City of Detroit
**City Engineering Division, Department of Public Works
Survey Bureau**

NOTICE OF PROPOSED CHANGE IN PROPERTY

Petition: X2754

PETITION NO. 2754
 UNIVERSITY of DETROIT MERCY
 C/O THOMAS ROBERTS ARCHITECTS
 458 ORANGE STREET
 WYANDOTTE, MICHIGAN 48192
 PHONE NO. 734 250 4032

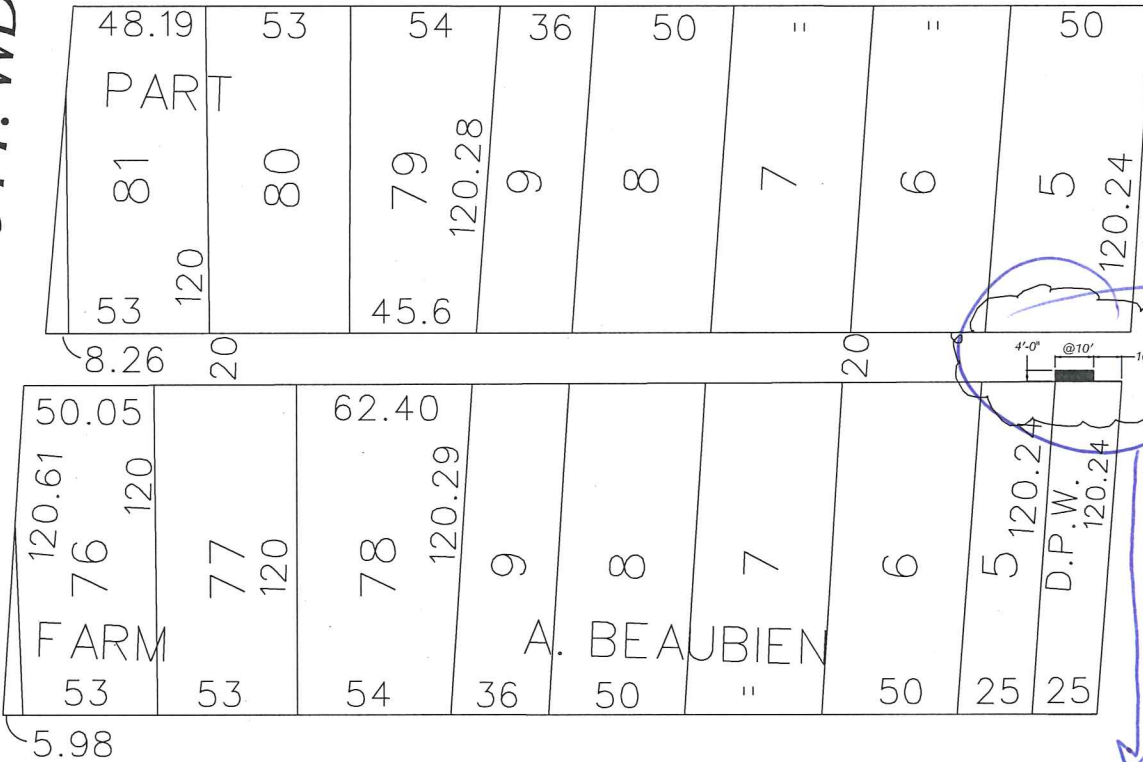
- Staircase Already exists, and it is built on top of DTE Electric's conduit. In case of any conduit work, The staircase may be destroyed.

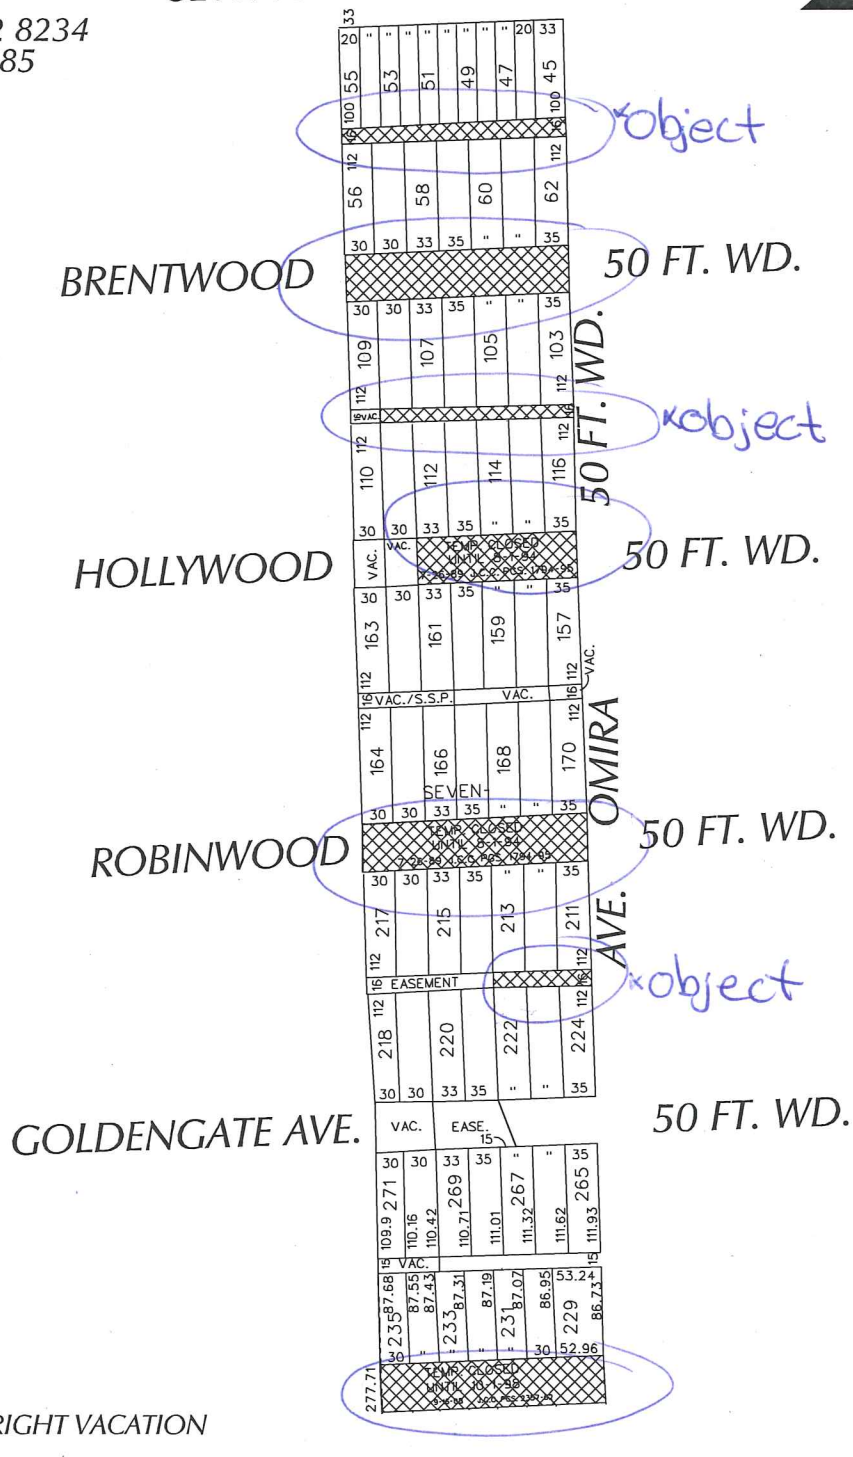
- We have overhead facilities at ① Alley south of Seven mile ② Alley south of Brentwood & ③ Alley south of Robinwood. Therefore we Object to outright vacation at these locations. We have no objections if easment is maintained for the full width of the alley.
